The Light company
Houston Lighting & Power South Texas Project Electric Generating Station P. O. Box 289 Wadsworth, Texas 77483

November 20, 1990
ST-HL-AE-3608
File No.: G25 & G04.02

South Texas Project Electric Generating Station
Units 1 & 2
Docket Nos. STN 50-498, STN 50-499
Responses to the NRC Request for Additional Information on the External Events Analysis in the Probabilistic Safety Assessment
South Texas Project Electric Generating Station (STPEGS)

Attachment 1
Responses to STP PSA External Events Questions

Open penetration in corridor to switchgear room (typical).

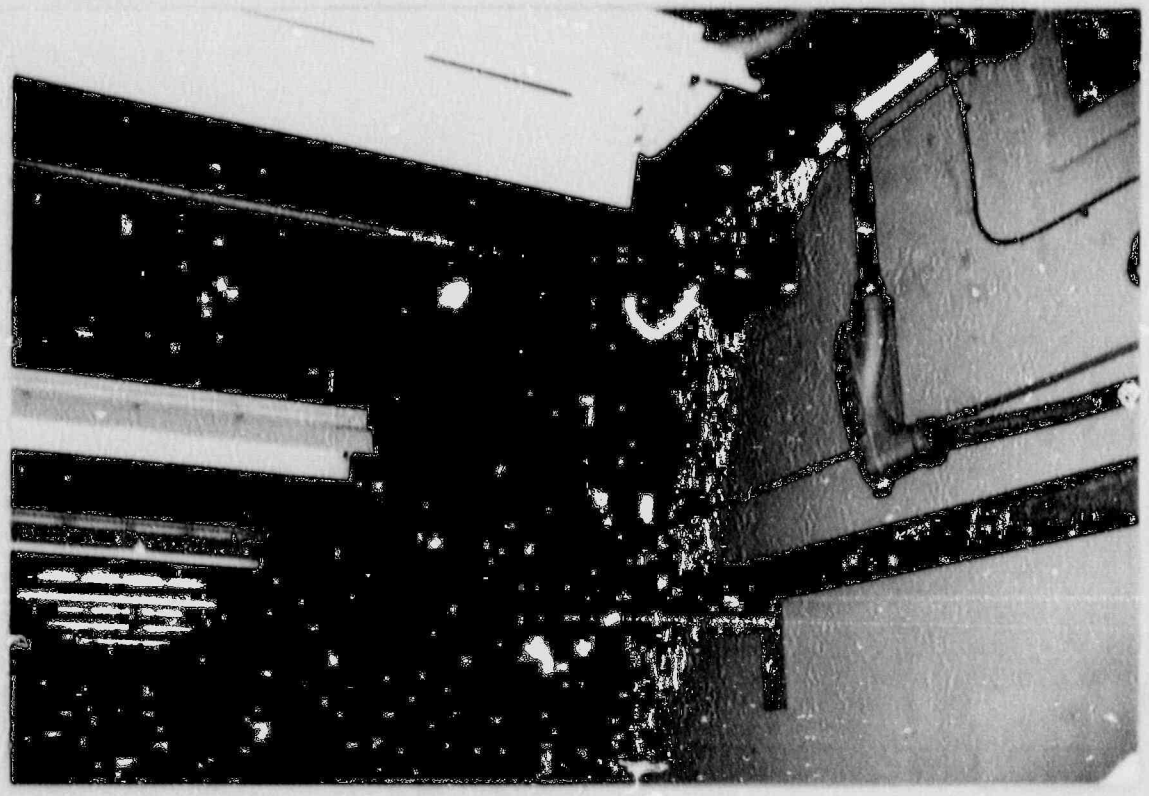
Q4: During the walkdown, an open penetration was noted in switchgear room C. Provide a discussion on how this penetration was treated in the PRA.

Each of the three switchgear rooms have small open penetrations which communicate from the switchgear rooms to a corridor. These penetrations are either unused or may have a conduit or fire protection pipe passing through it. These penetrations are generally 8 or 10 feet off the floor. The ceiling in the switchgear rooms are much higher than these penetrations. A photograph is attached (Attachment 1) to illustrate these penetrations.

In the case of the three switchgear rooms, i.e., zones Z004, Z042 and Z052, these penetrations are not considered important for the analyses in the PSA for other than smoke propagation and thus are not considered in the PSA external events analysis. In the case of smoke propagation, the PSA assumed that the smoke in the switchgear rooms would be communicated into the corridors and these scenarios were analyzed.
